CCO: 77 Suppl. No. 0 Contract No. 04 - 0120F4 Road SF-80-13.2/13.9

This change order provides Quality Assurance (QA) improvements for the Orthotropic Box Girder (OBG), and Tower assemblies. Quality Assurance shall be improved by increasing welding report requirements and by implementing a Quality Assurance database along with a physical tagging procedure (green tagging procedure) for fabricated assemblies. The tagging procedure, in conjunction with the database system, establishes a process that tracks, verifies, and documents incremental progress for fabricated sub-assemblies and assembly stages.

Figure 1. SFOBB Status Tag (In-Process, Yellow Tag)

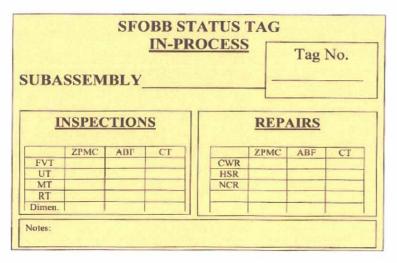
- 3.2. Prior to submitting components for formal acceptance the Contractor shall implement In-Process verification that shall include the following:
 - 3.2.1. The yellow In-Process tag (figure 1) shall be affixed to the component, by the Contractor's representative, before part is moved from welding station. The yellow tag shall document that the items listed below have been completed.
